Re: Veranda Apartments
9000 Veranda Rd. NE
Traffic Circulation Layout
Architect's Stamp 05-16-2022 (**G20-D052**)

RE: Veranda Apartments – TCL Revision 2

1 TCL - Site Plan
1" = 20'-0"

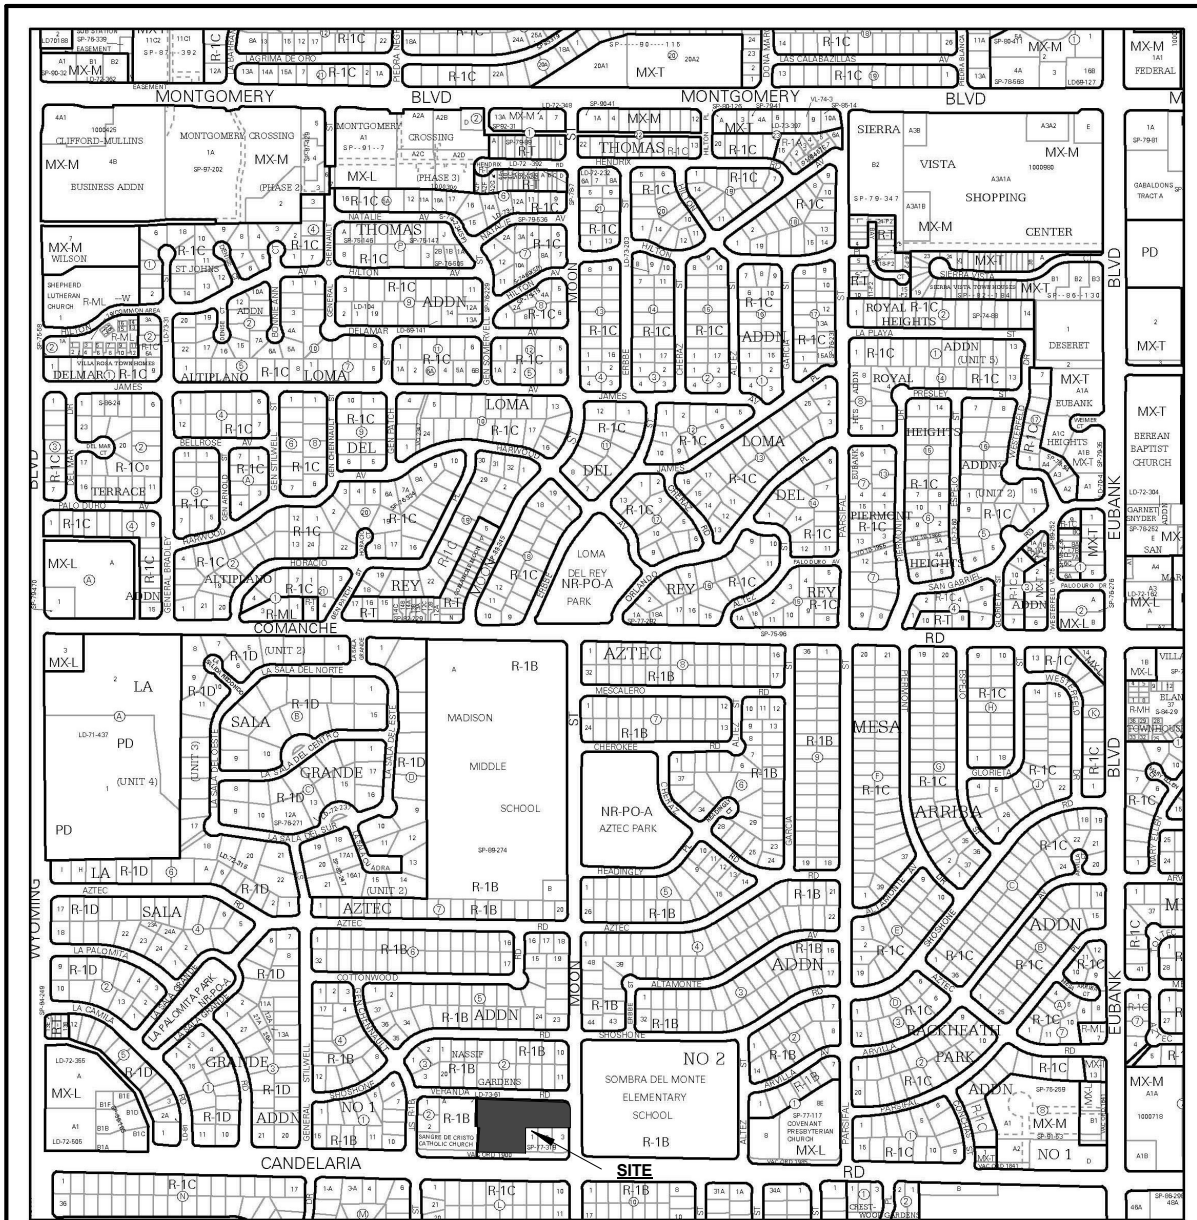
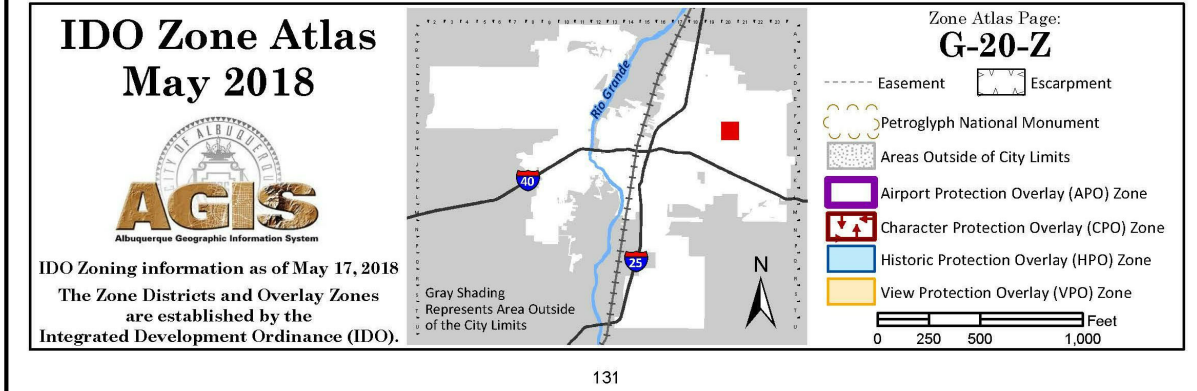
1. Sidewalk (existing):
 - There are humps/bumps connecting sidewalk portion/segment throughout Veranda frontage on public sidewalk. This damage segment through frontage will need to be remove/repared/replaced due to the public safety issue for the City. Please identify these segments on your Site Plan. **Please see the bubbled sidewalk along Veranda which shows a dark concrete hatch. Those concrete sidewalks will be removed and replaced with new concrete sidewalk.**

- Interior sidewalk on site is damaged, chipped/ tapered (6"-8"), uneven joints/connection and a safety concern to occupants. Please identify on Site Plan to be addressed/replaced in kind to have an even surface to compromised pedestrian movement through site. **Due to it being a city rehab project, there are limited funds and not enough to replace all sidewalks throughout. All of the sidewalks along the accessible route will be replaced and be made to meet ADA standards as well as any sidewalk that is a liability to the owner.**

7 Concrete Drive Pad
1/4" = 1'-0"

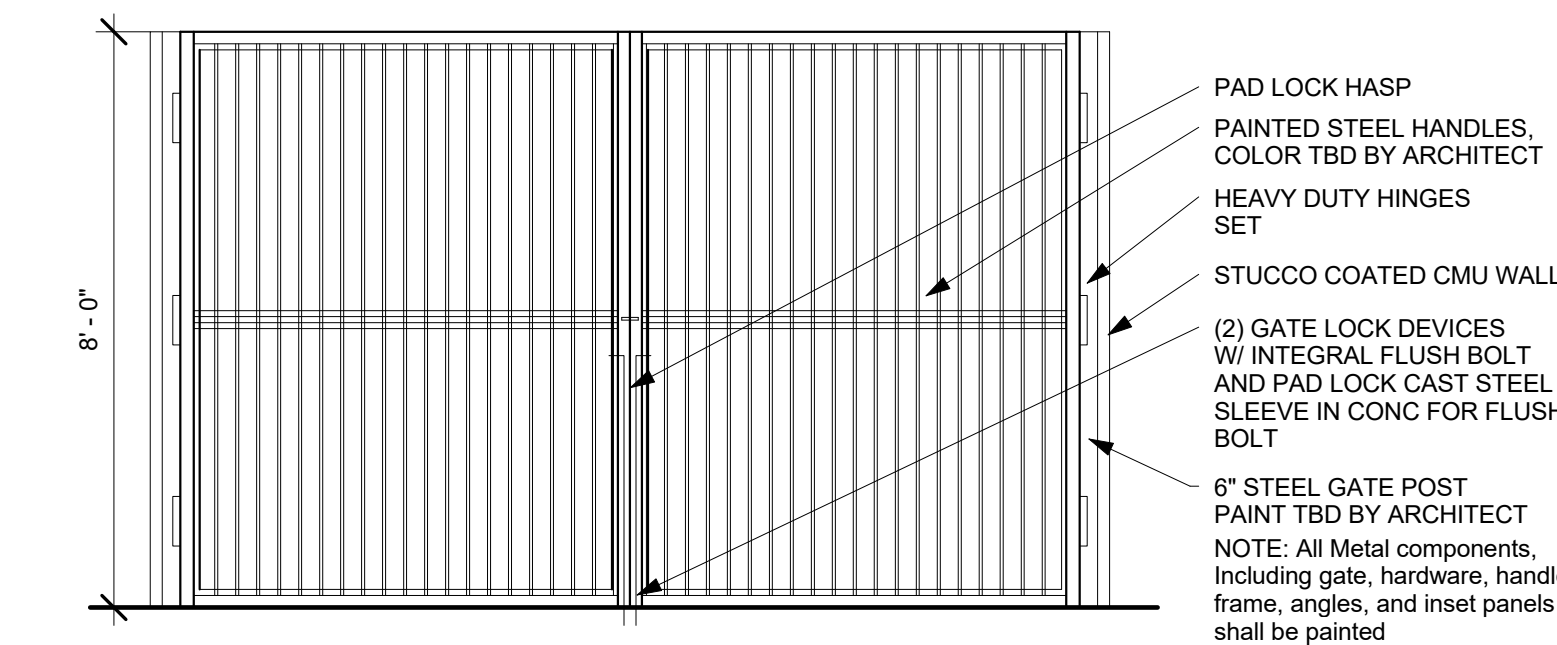
4. Detail 7/TCL 1.1:
 - Modify note to say 2% max for cross slope and 5% max for running slope. **Please see corrected note**
5. Detail 10/TCL 1.1:
 - Landing should read 2% max on all directions. **Please see corrected note.**

TCL12

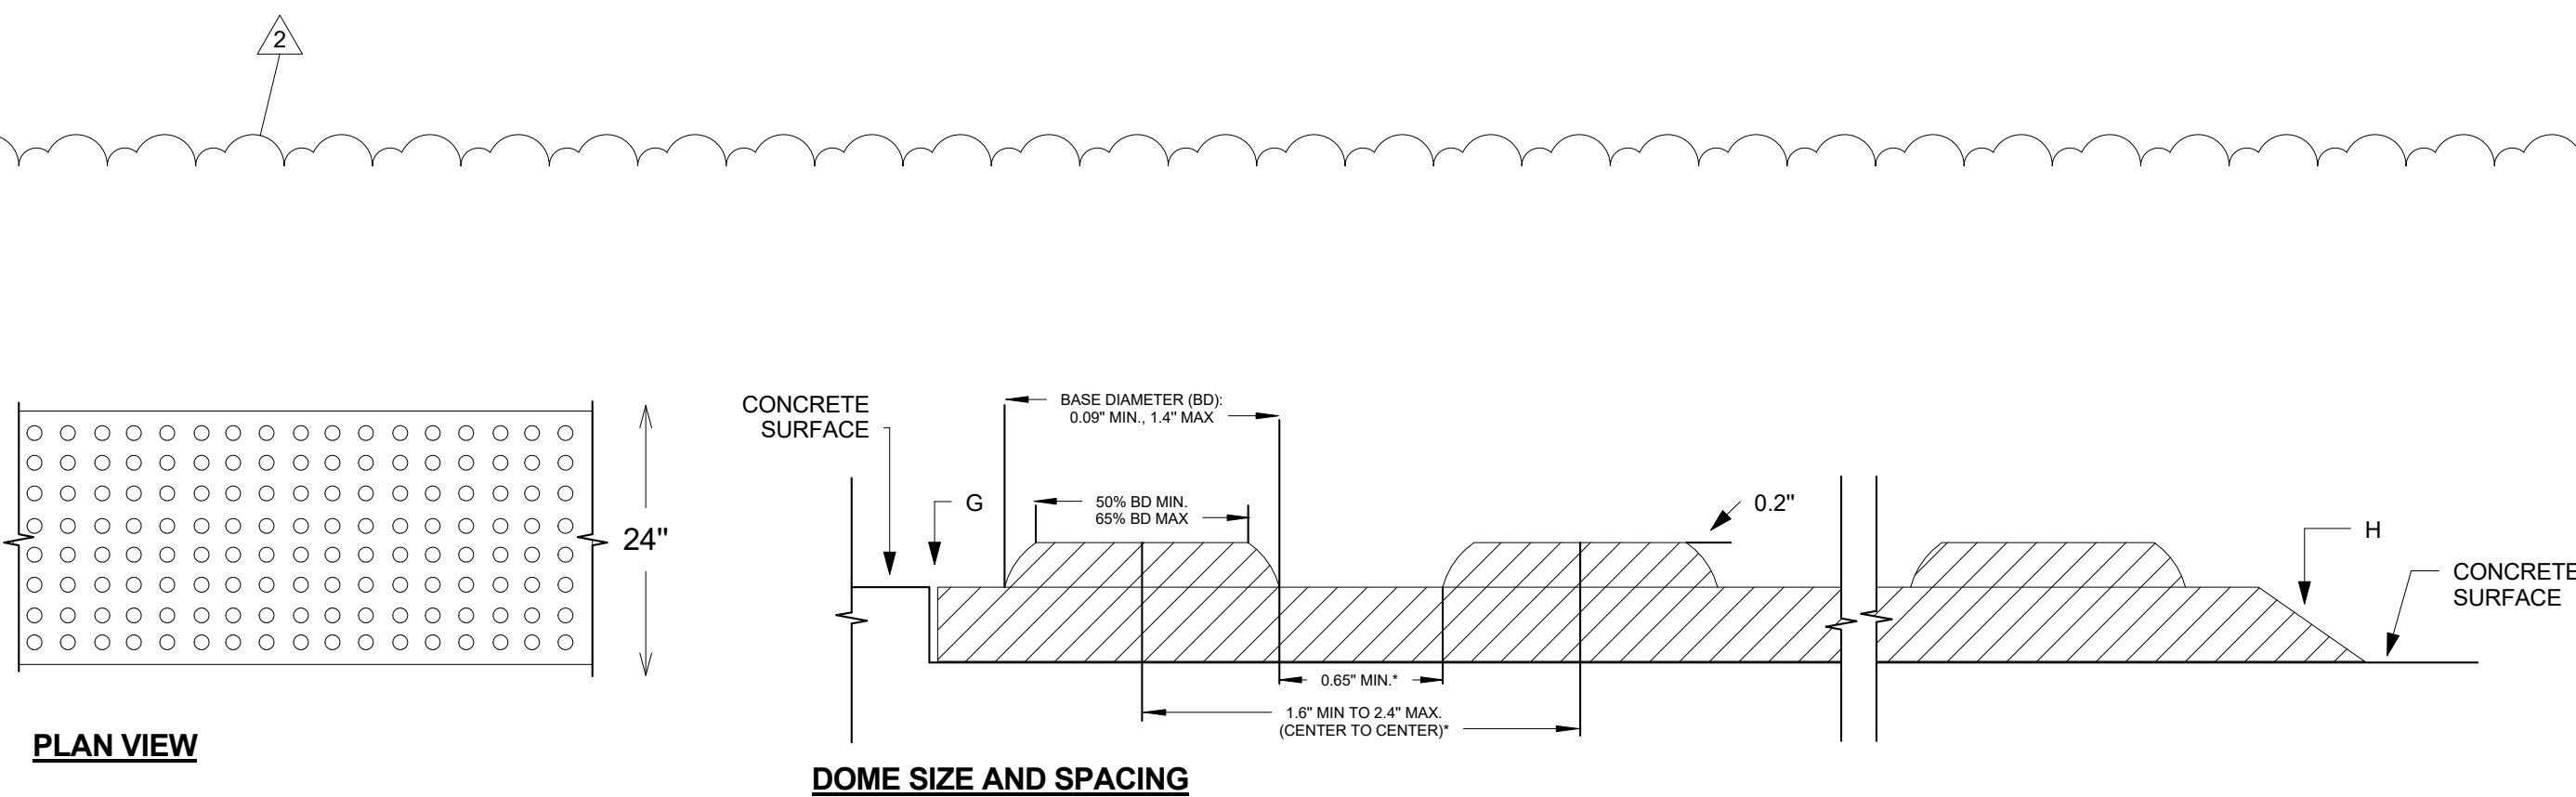
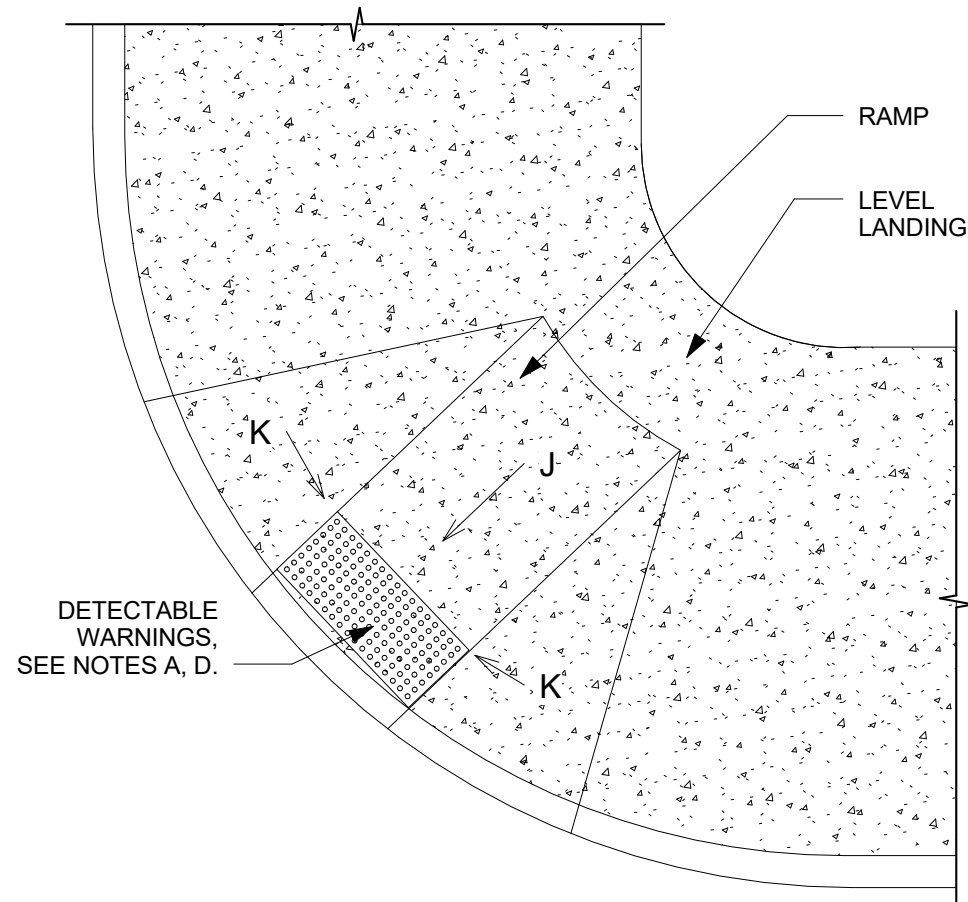
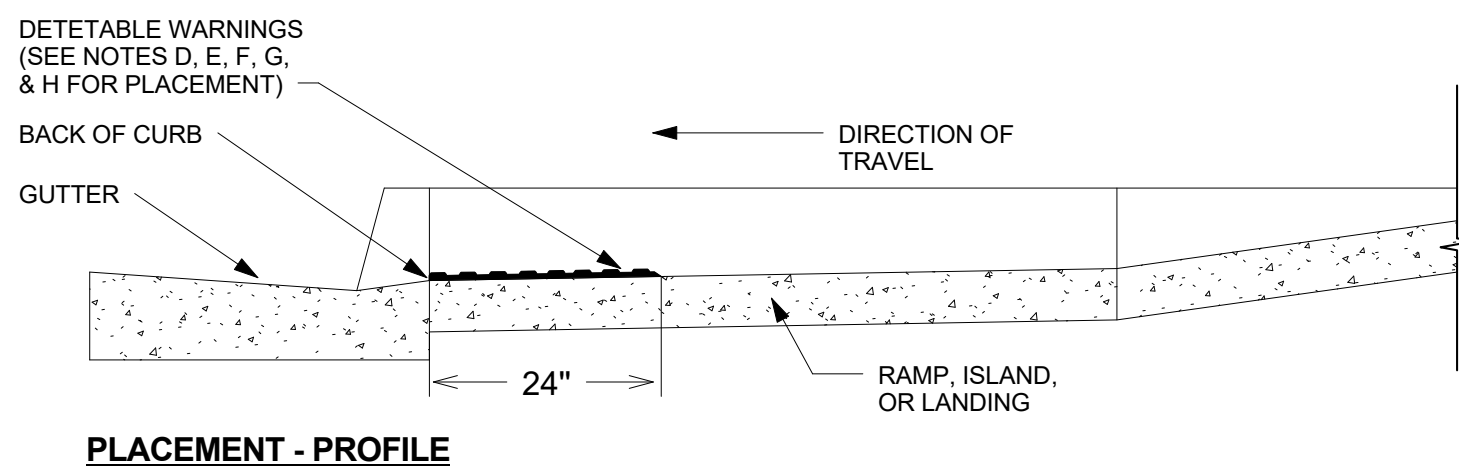
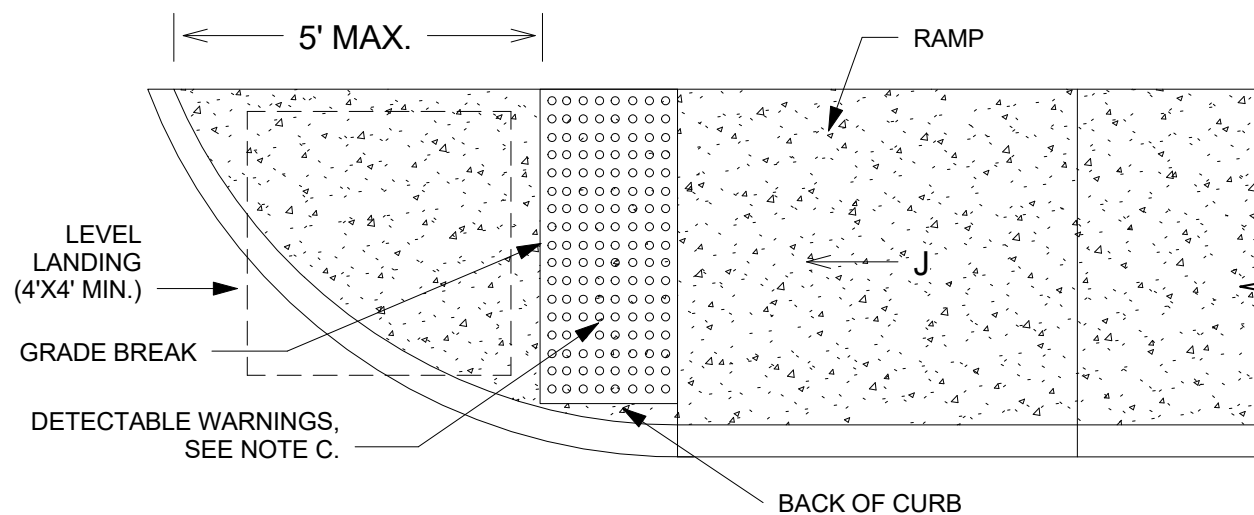
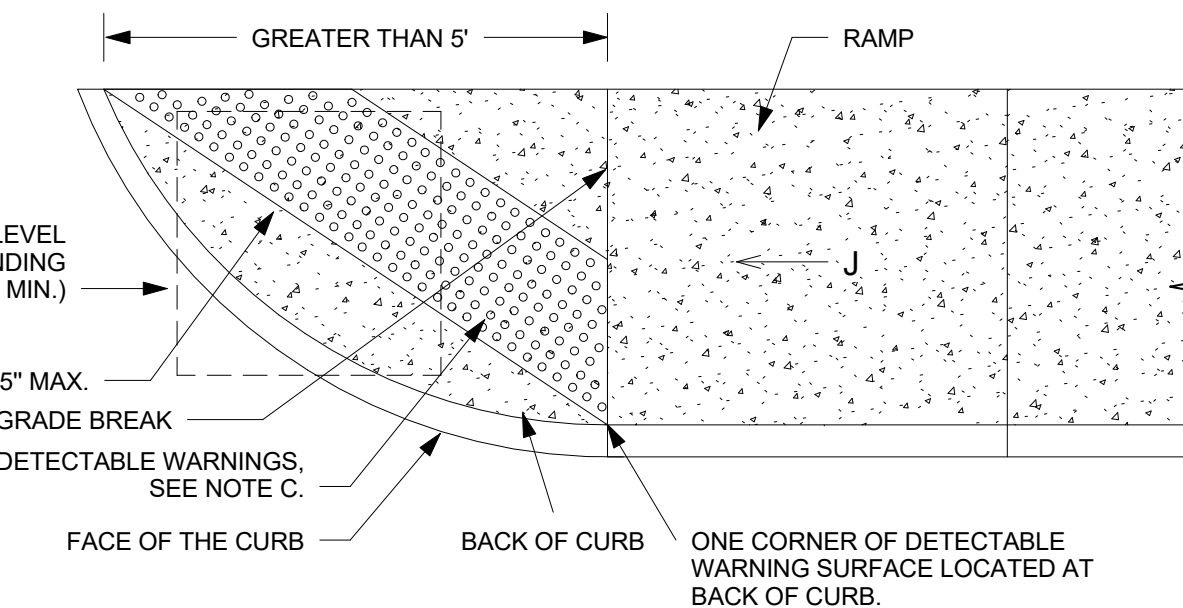
3. Corner of Moon and Veranda ramp: Truncated domes will need to be installed (Detectable warning surfaces). A note will need to be provided. **Please see added note 29 as well as note 1/TCL1.3 for Truncated Dome Details.**
